NOTICE OF ADDENDUM  
ADDENDUM NO. 1  
CONTRACT NO. 8504  
CEDAR STREET ASSESSMENT DISTRICT – 2021 & SOUTH STREET, HIGH STREET, AND WEST  
WINGRA DRIVE ASSESSMENT DISTRICT – 2021

Revise and amend the contract document(s) for the above project as stated in this addendum, otherwise, the original document shall remain in effect.

11866  
 U-1

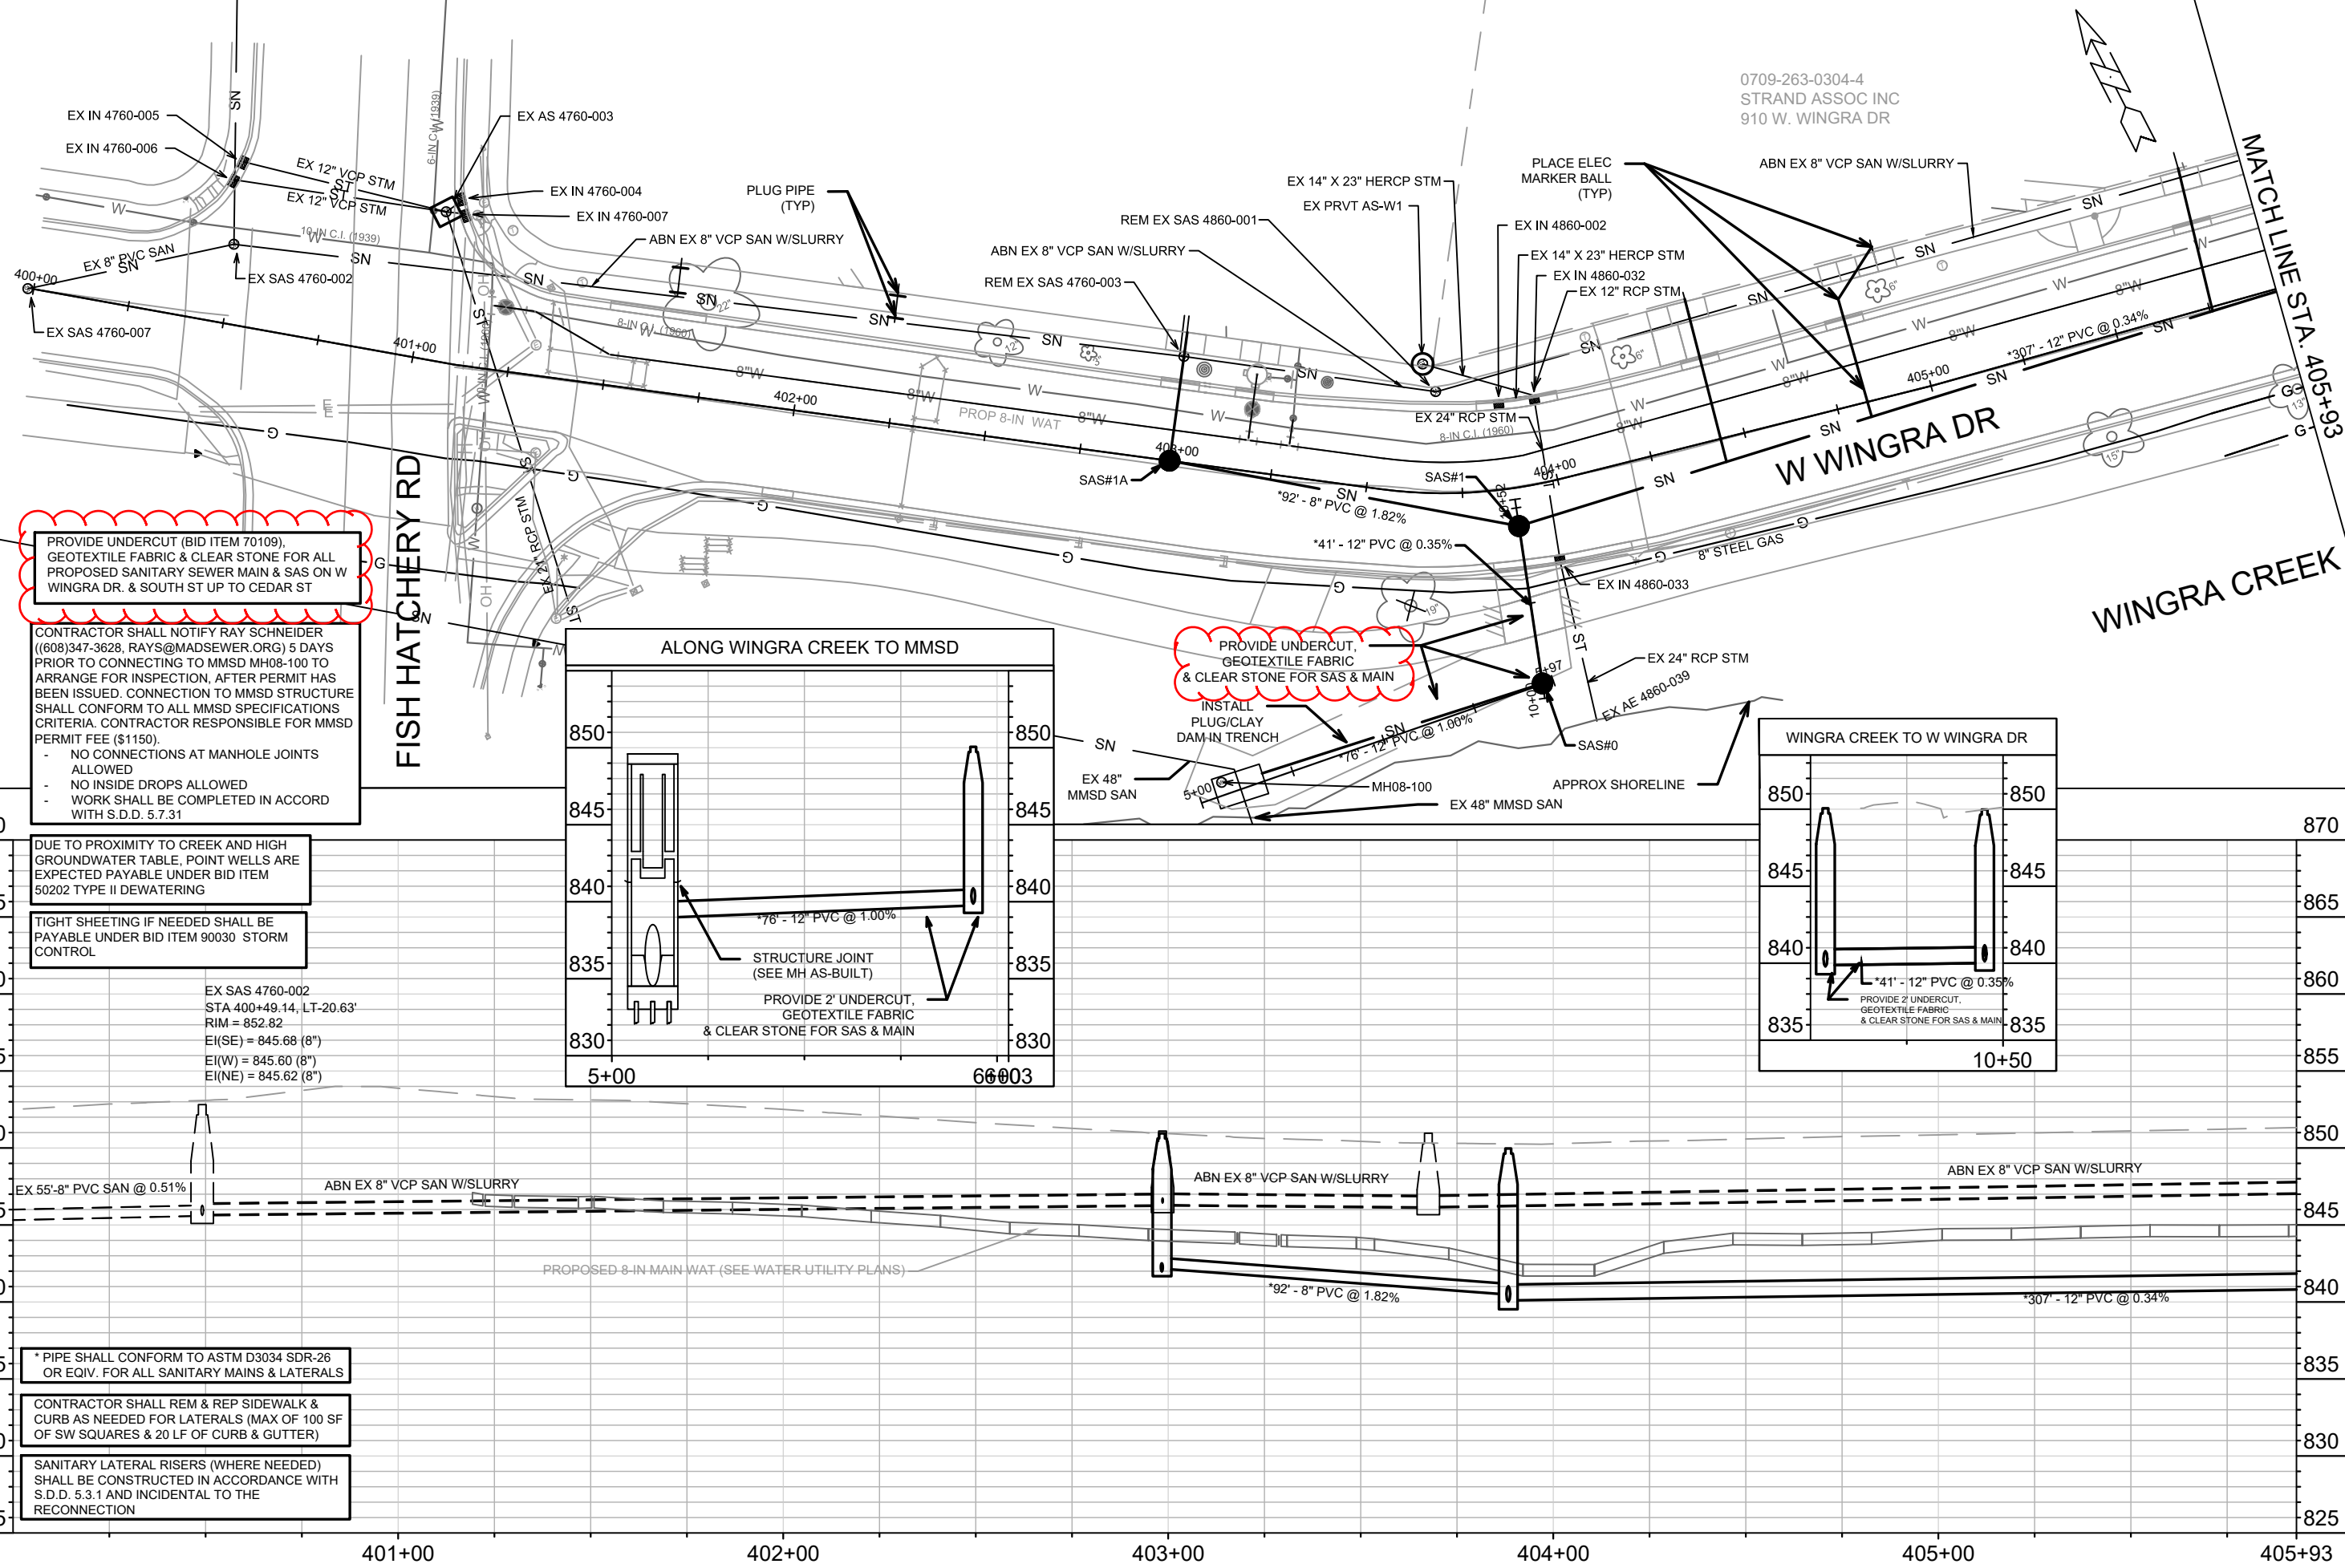
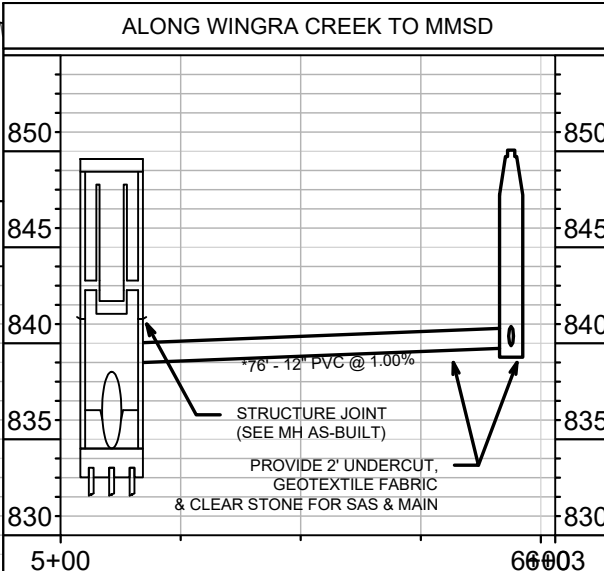
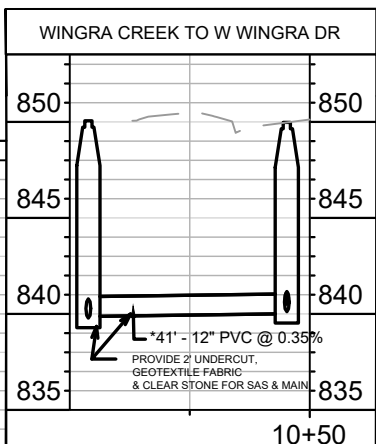
U-1 – U-8: Revised plans to updated undercut information.

PROVIDE UNDERCUT (BID ITEM 70109), GEOTEXTILE FABRIC & CLEAR STONE FOR ALL PROPOSED SANITARY SEWER MAIN & SAS ON W WINGRA DR. & SOUTH ST UP TO CEDAR ST

PROVIDE UNDERCUT, GEOTEXTILE FABRIC & CLEAR STONE FOR SAS & MAIN
